WATERSIDE AT LAKE WOODMOOR

PUD DEVELOPMENT PLAN/PRELIMINARY PLAN

El Paso County File Number: PUDSP-22-009

PUD MODIFICATIONS

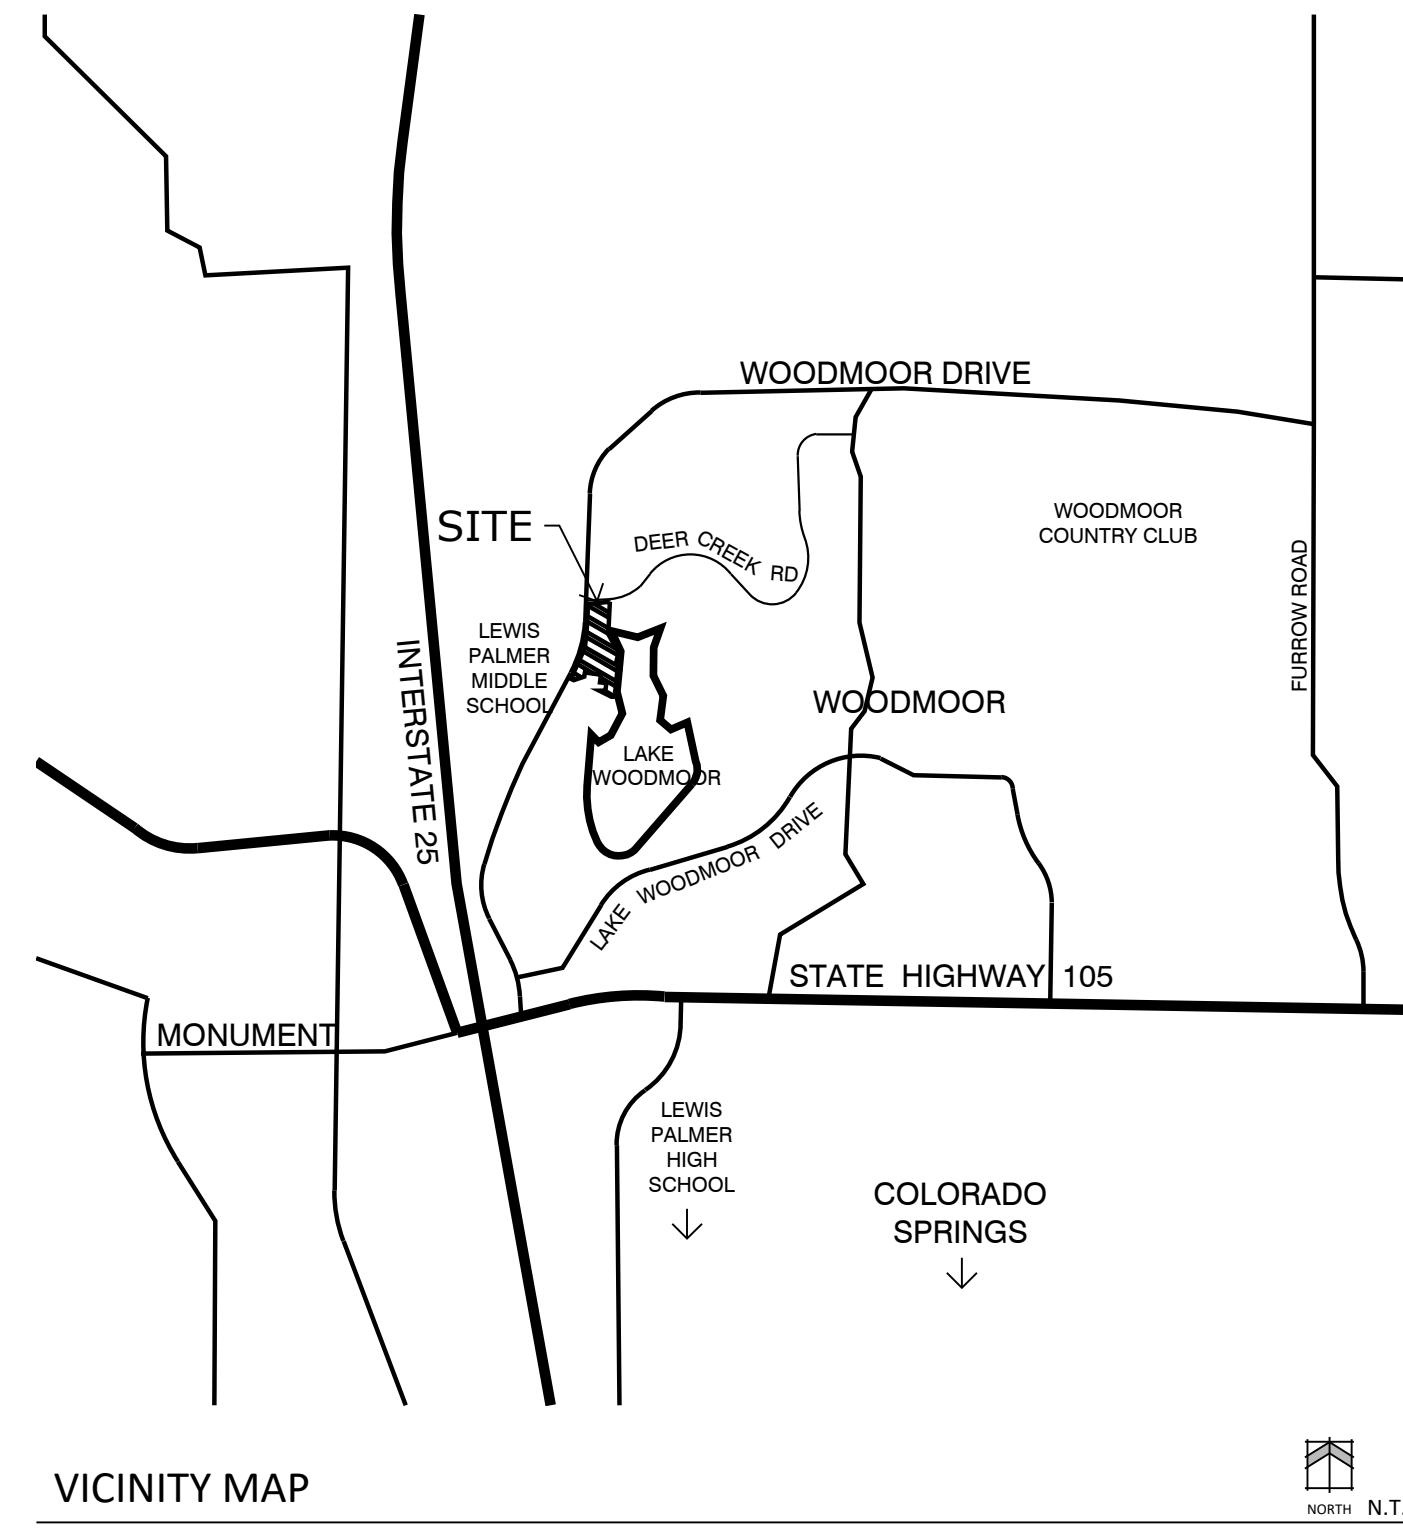
See LOI for comments regarding deviation requests. Please update table based on revisions made due to comments.

PRELIMINARY UTILITY PLAN

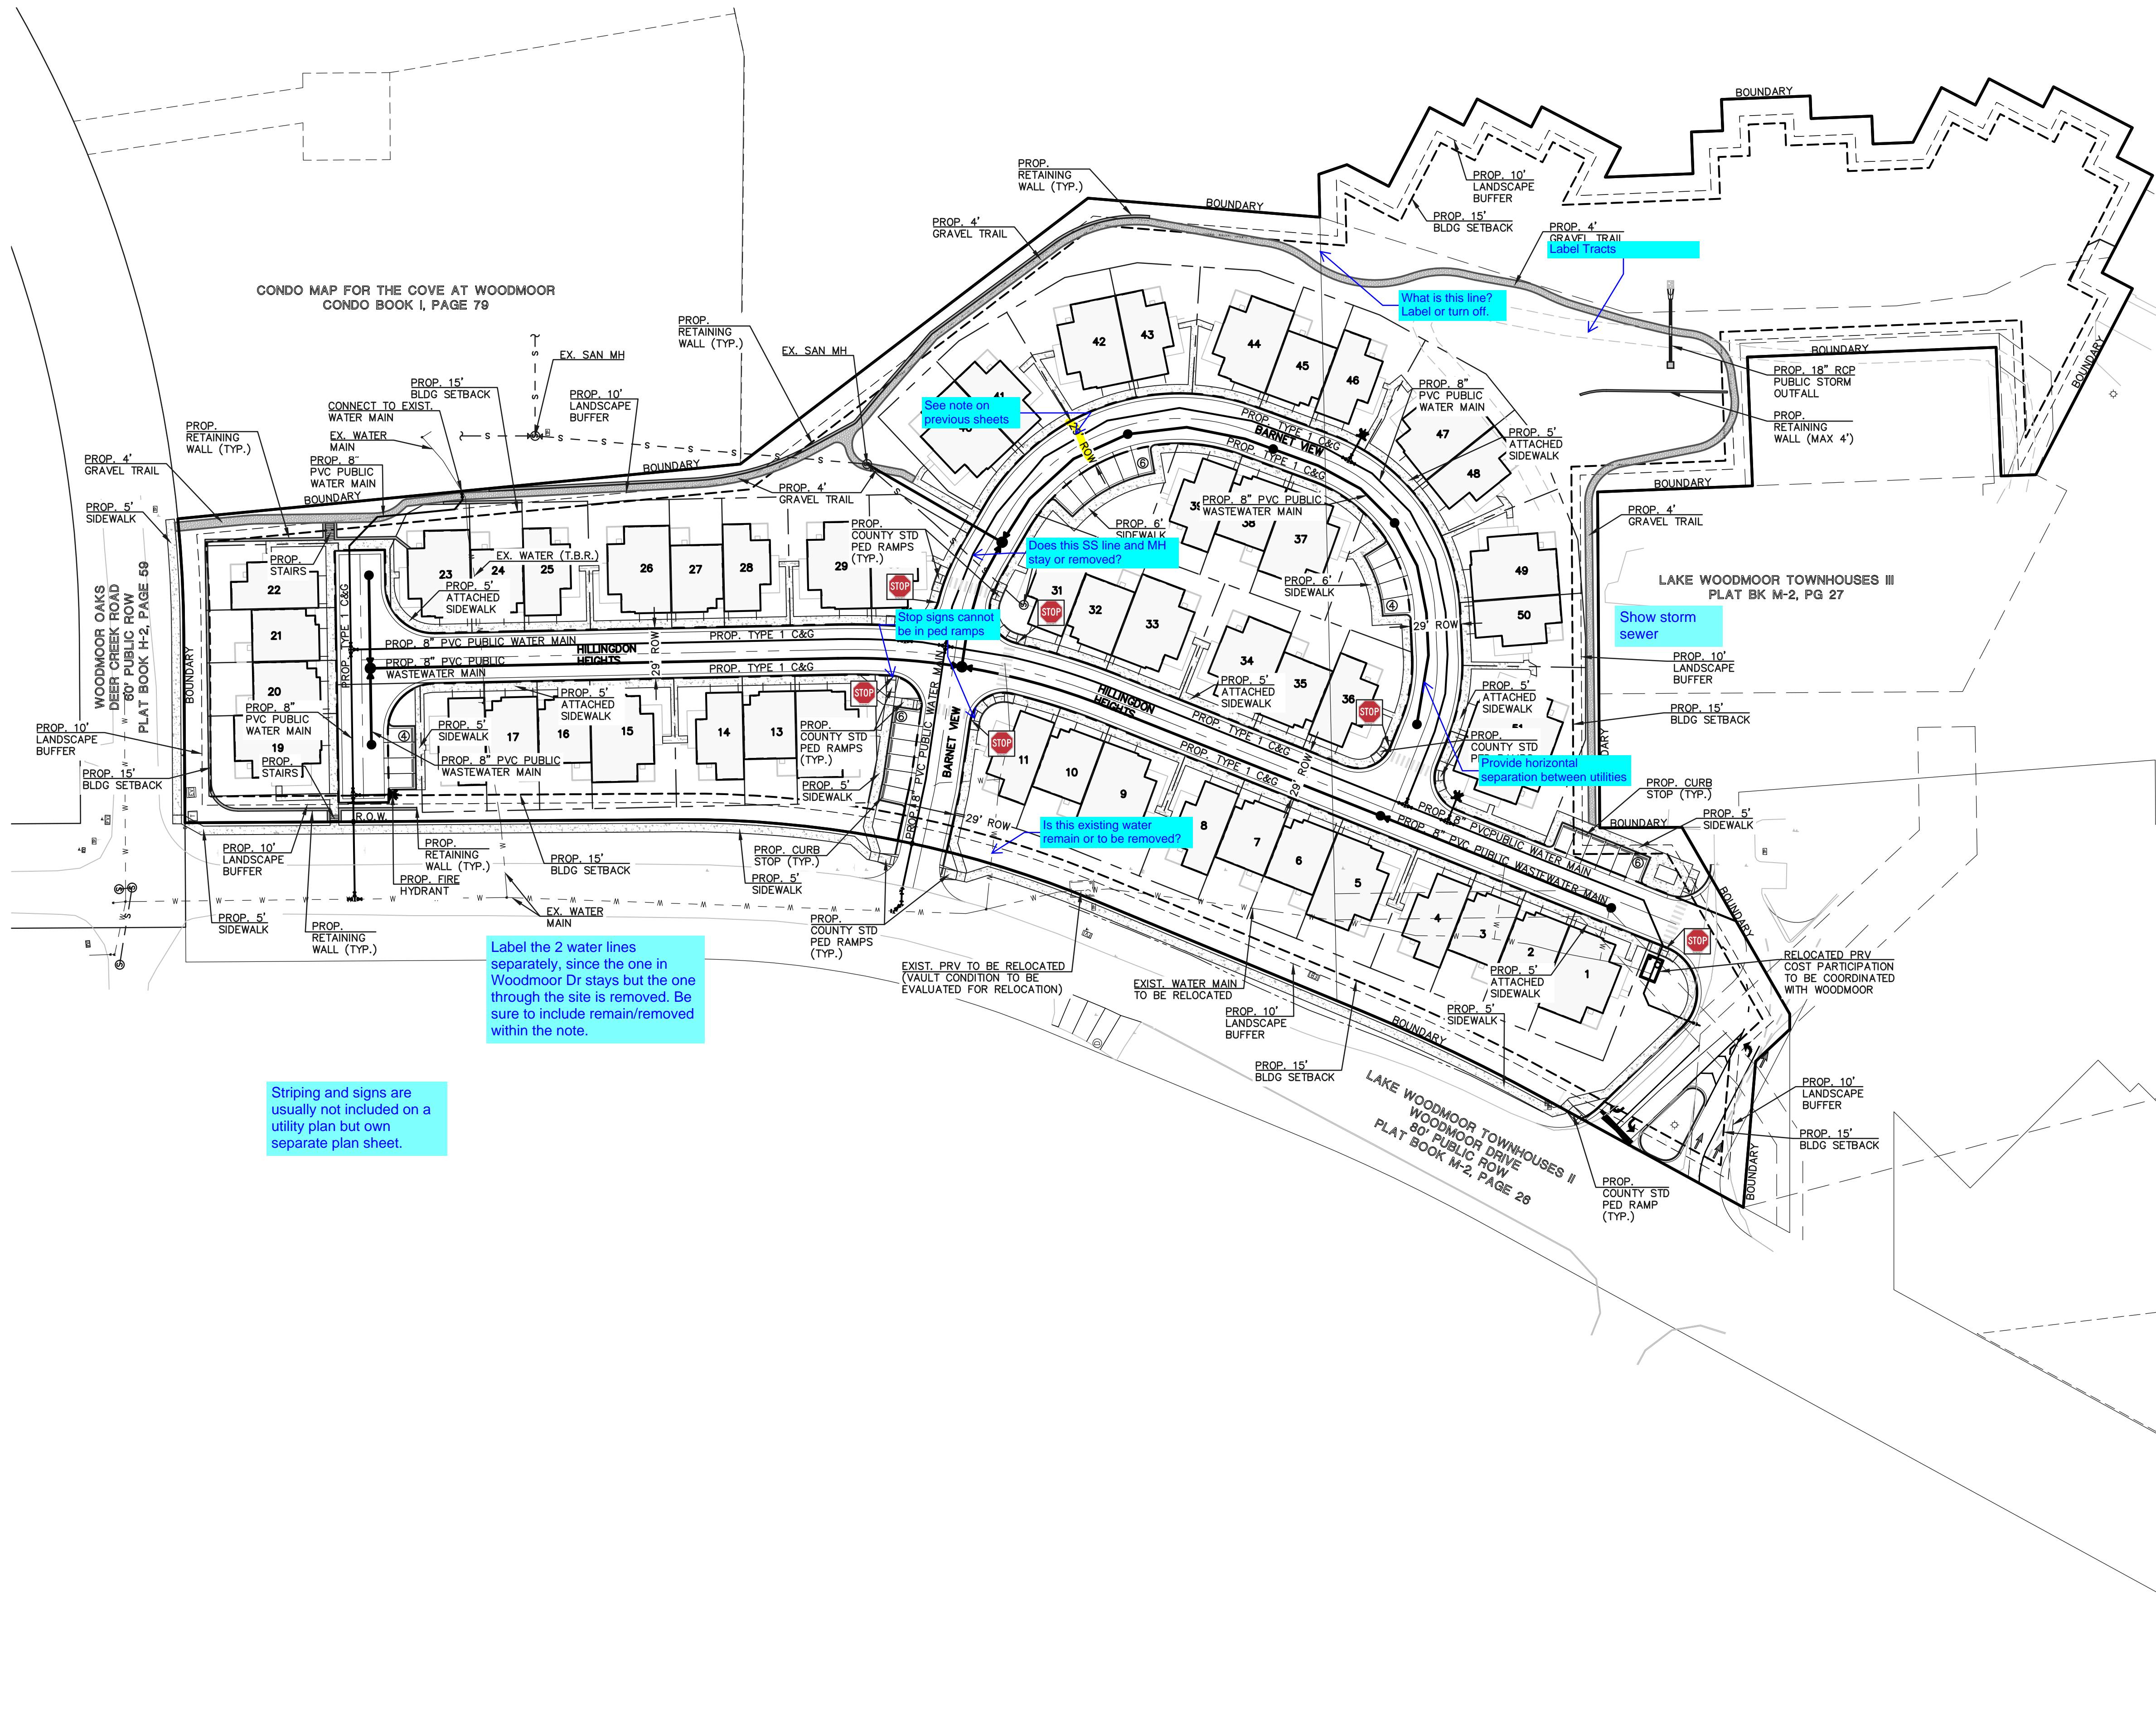
Label the 2 water lines separately, since the one in Woodmoor Dr stays but the one through the site is removed. Be sure to include remain/removed within the note.

Striping and signs are usually not included on a utility plan but own separate plan sheet.

See note on previous sheets

Does this SS line and MH stay or removed?

Stop signs cannot be in ped ramps

Is this existing water remain or to be removed?

What is this line? Label or turn off

Label Tracks

Show storm sewer

Provide horizontal separation between utilities

ZONING MAP

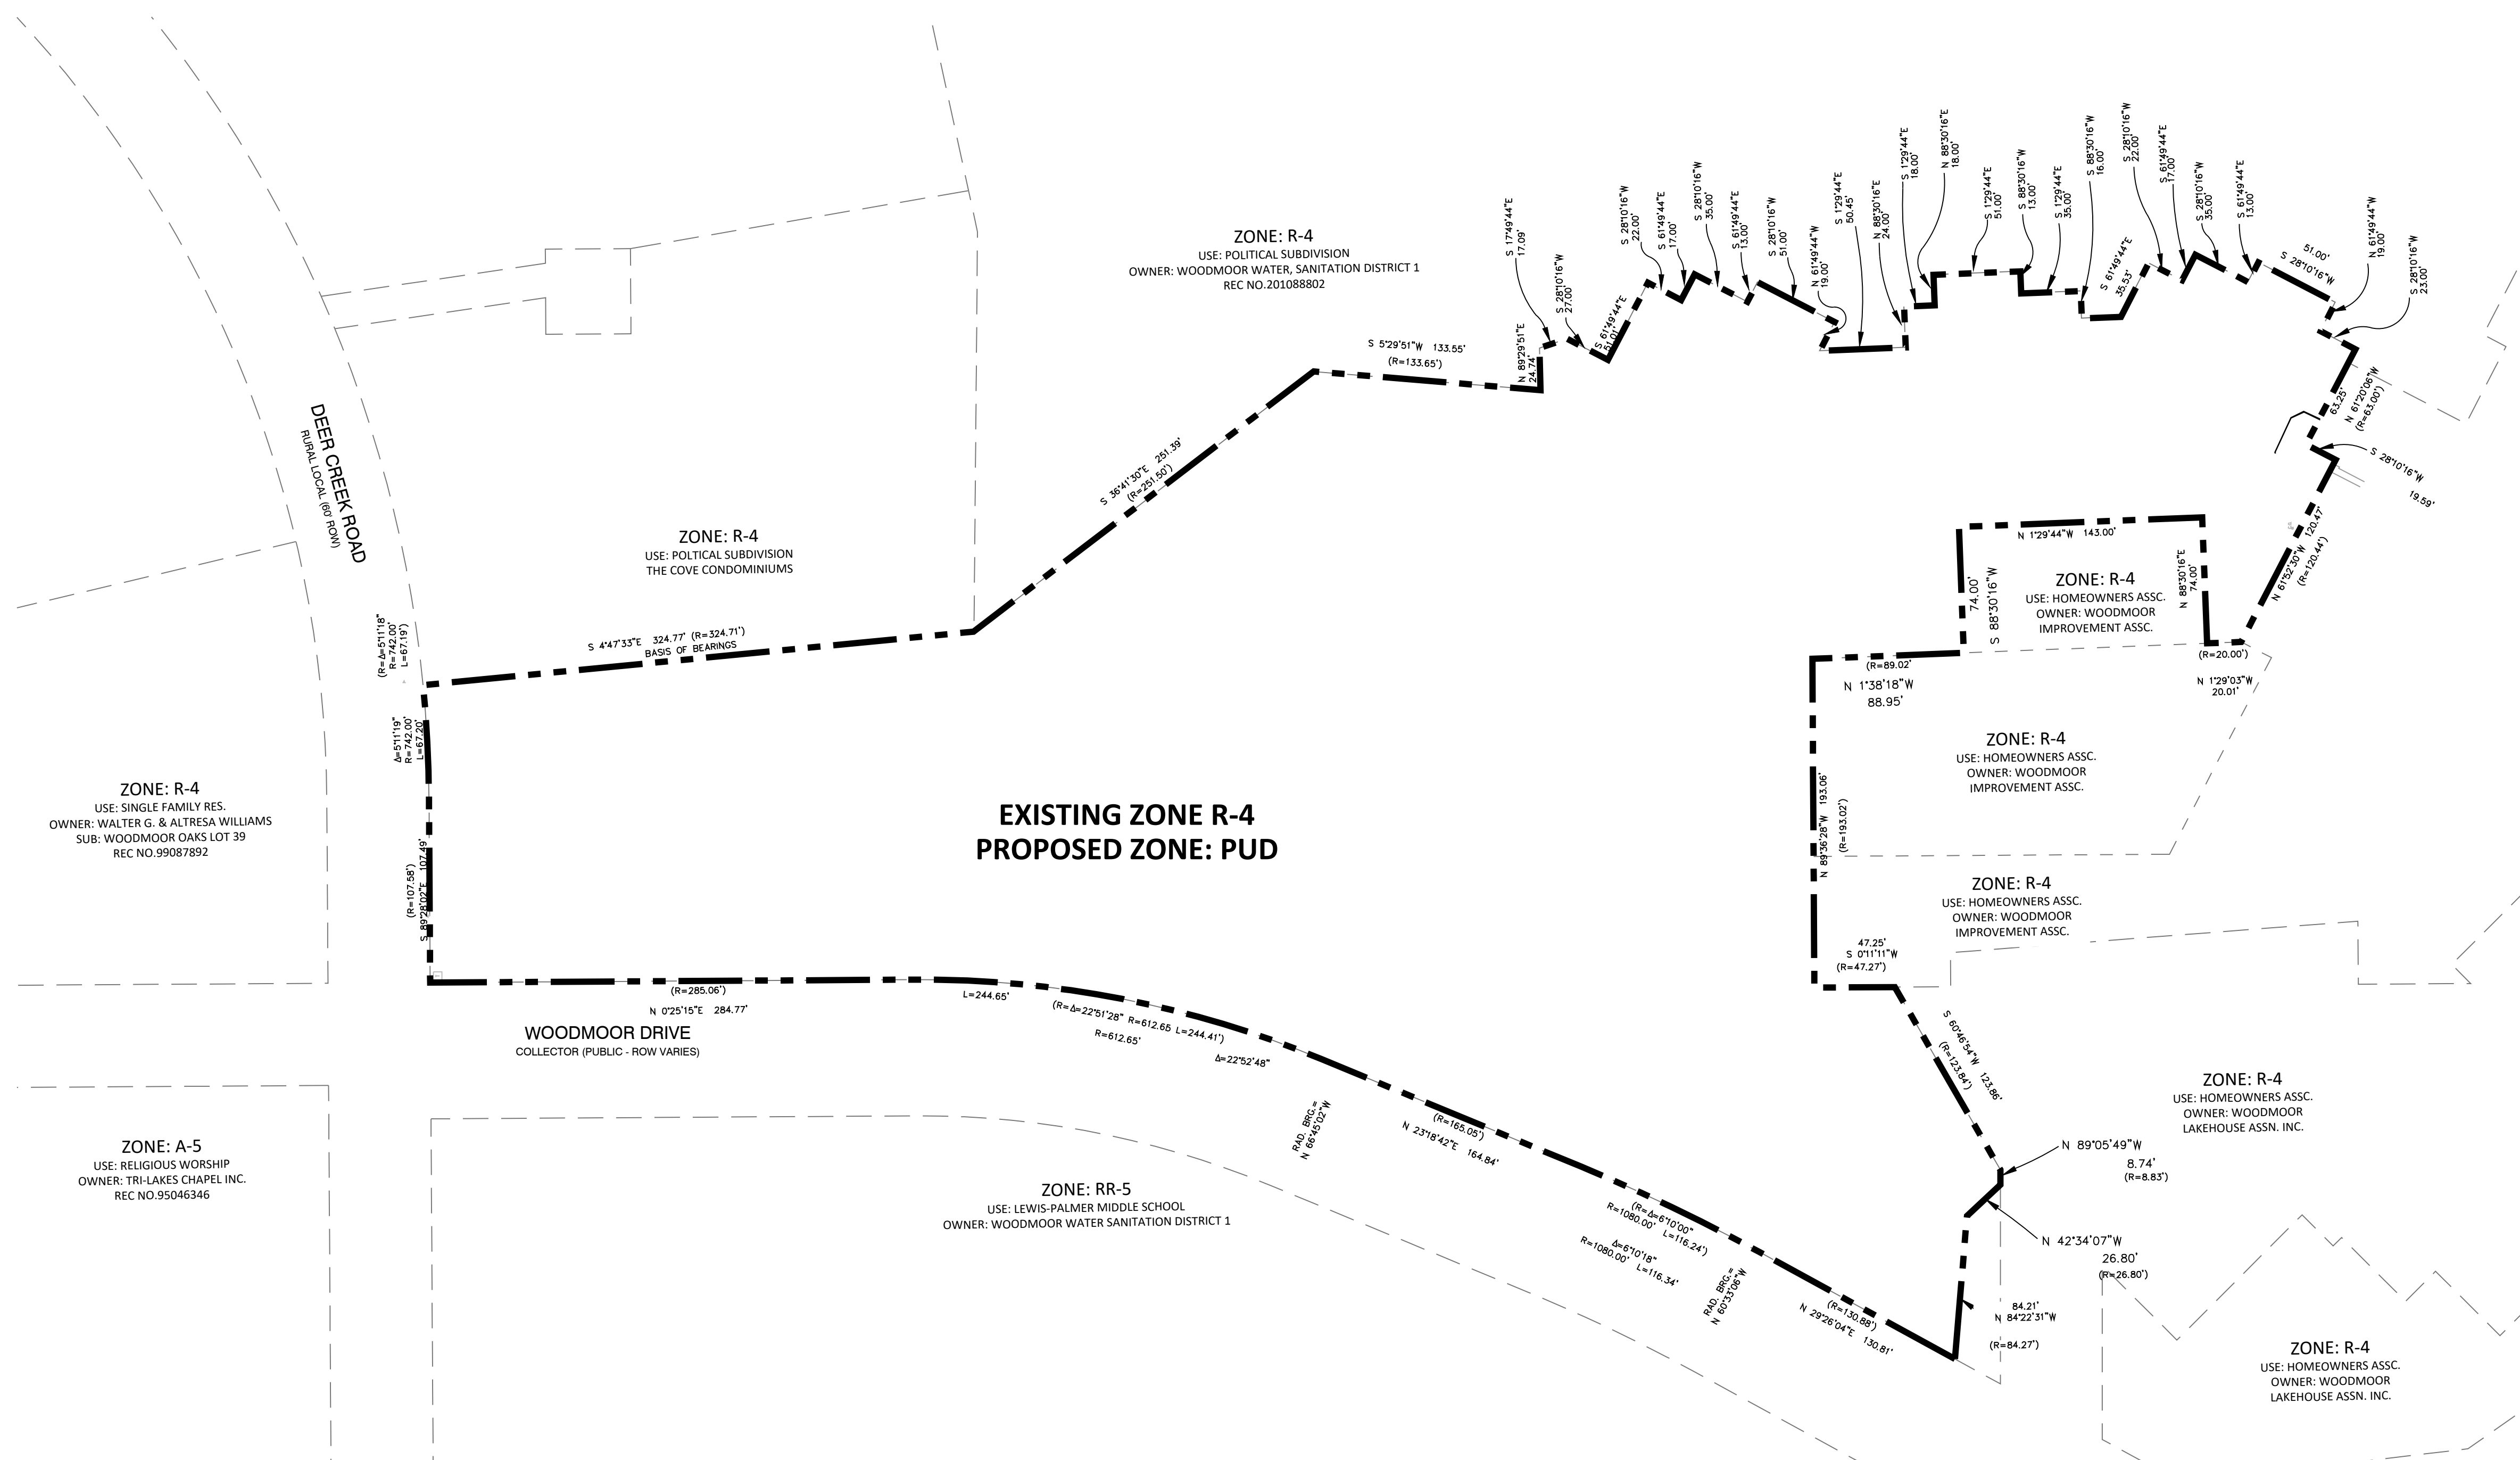
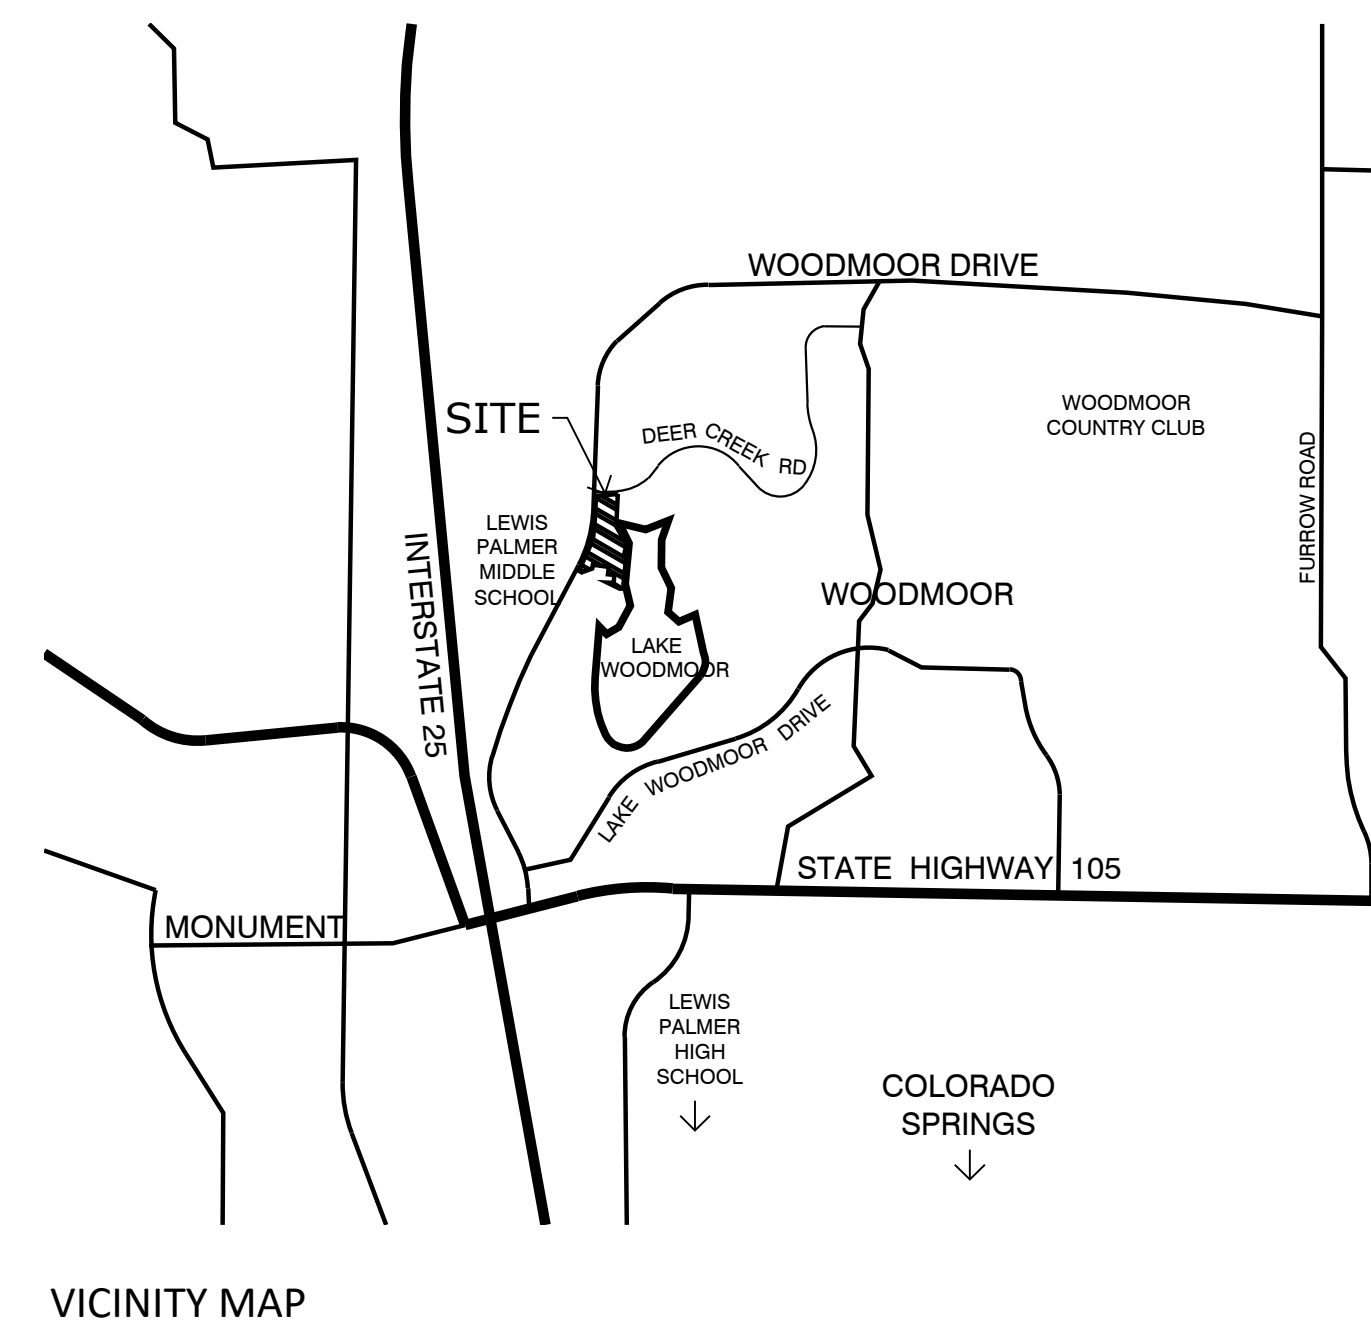
Update to match changes made on cover sheet
